AMD Alchemy™ Au1100™ Processor

Document Revision History

Figure 37. TOY and RTC Block Diagram

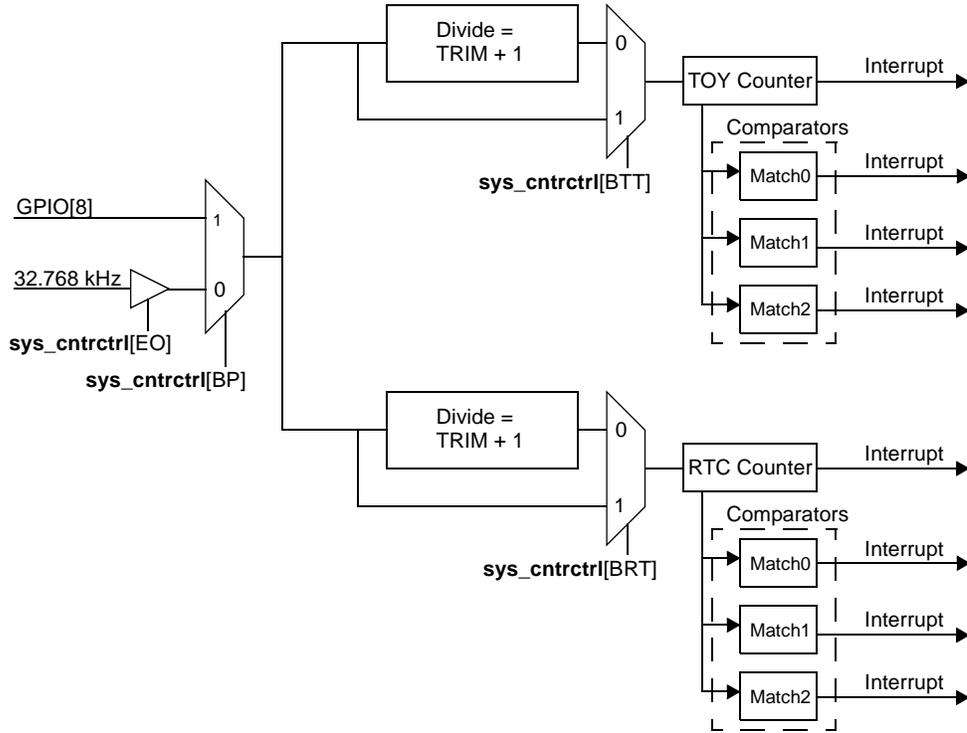
Replace Figure 37. TOY and RTC Block Diagram and 7.2.1 Time of Year Clock and Real Time Clock Registers with the following new material.

Figure 37. shows the functional block diagram of both the TOY and the RTC. The registers used to implement the block, including the counter control register (**sys_cntrctrl**), are described in the following section.
